**APPENDIX E**  
**PACDIV COMMENTS AND WILLBROS RESPONSES**

DATE 28 Sep 94	PAGE 1 OF 4
PROJECT TITLE CONTRACT NO. N62742-89-C-0069	DD FORM 1391
FIRE/RISK ASSESSMENT STUDY, RED HILL TUNNEL COMPLEX	DESIGN CRITERIA
PRELIM. PLANS	FNL SPCS & PLNS

PROJECT TITLE		DD FORM 1391	DESIGN CRITERIA
Fire, Life Safety and Environmental Risk Assessment/Analysis	X	95% Report	FINAL PLAN & SPECS.
ACTIVITY	REVIEWERS		
FISC, Pearl Harbor		ARCHITECTURAL	CIVIL
		STRUCTURAL	COST & SPECS.
LOCATION	X	MECHANICAL	
RED HILL COMPLEX		ELECTRICAL

EXHIBIT 4-1 (continued)

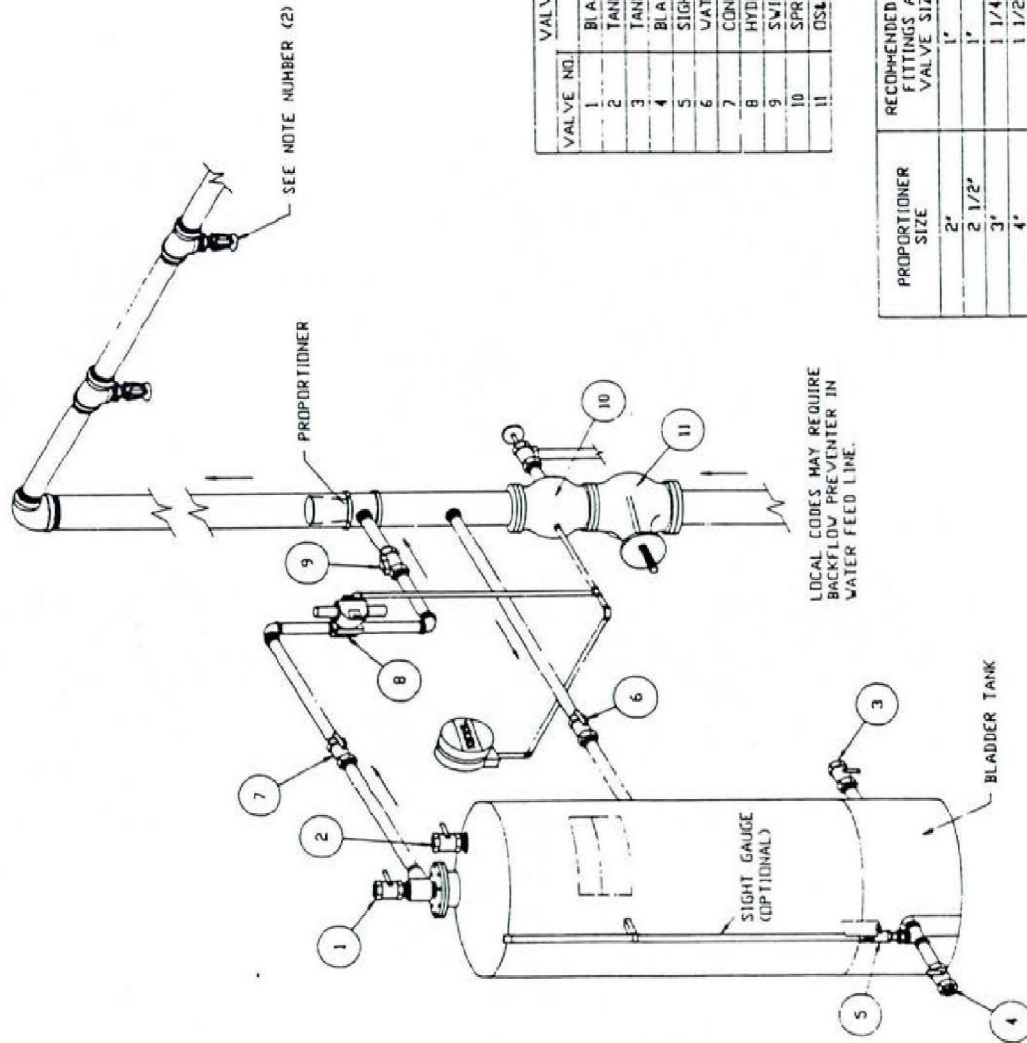
DWG NO. OR SPEC PARA. NO.	ITEM NO.	COMMENTS	ACTION
P. 4-31	9	Section 4.6.2.9, Fire Suppression: a. Provide a concept sketch of the recommended AFFF deluge system.	See Exhibit 4-1
		b. Discuss why AFFF deluge system was selected, i.e., why not other alternative systems? Also, see comment item no. 1.6. above.	See Sectn. 4.3.15
P. 4-31	10	Section 4.6.2.10, Ventilation: a. See comment item no. 6 above. b. 2nd sentence: is this bulkhead door have an automatic closure device? Is one recommended/necessary?	Sectn. 4.6.2.10 revise
P. 4-32	11	Section 4.6.2.11: Please elaborate on this sentence: i.e., what kind of "centralized role" should FISC play in the Fire Protection Program? Their staffing is limited.	Sectn. 4.6.2.11 revised
